Attachement with e-mail dated 16th March 2018 concerning cracks in the stiffeners ring of type Z23A tank wagons series Zacns, capacity 87m3 ans Z24A, tank wagons series Zacns of 97 m3

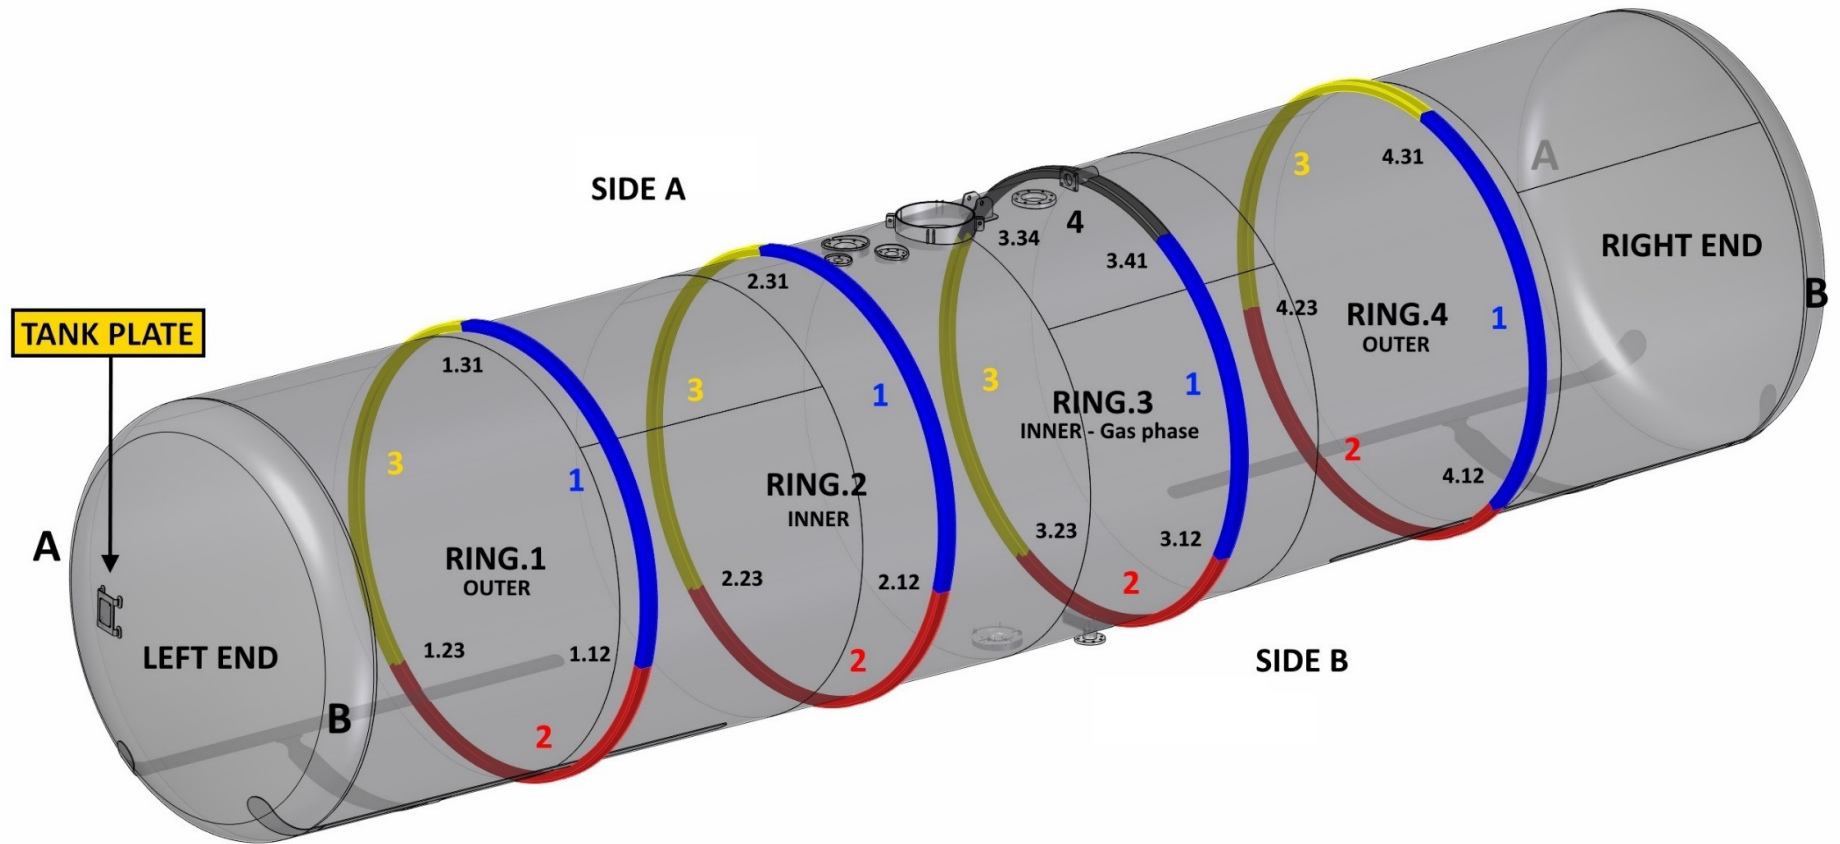
Light blue arrows point at the possible cracks positions

For the exact position of the concerned welds see picture 2: tank 3D model snapshot, where applicable position numbers are given, for welds placed at the stiffening rings)

Tank 3D model snapshot, where applicable position numbers are given, for welds placed at the stiffening rings

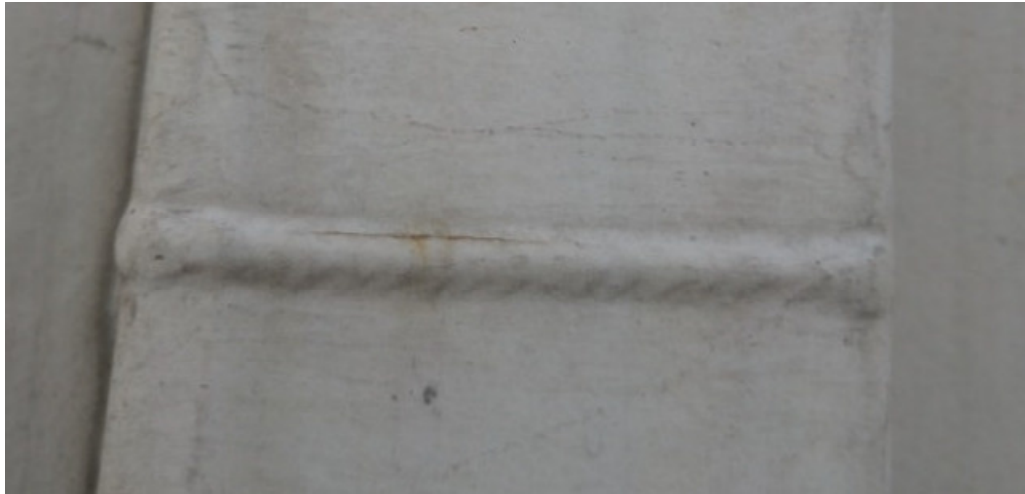
Please check the welds on position 1.12, 2.12, 3.12, 4.12, 1.23, 2.23, 3.23 and 4.23. There is no need for check of the welds on position 1.31, 2.31, 3.34, 3.41 and 4.31.
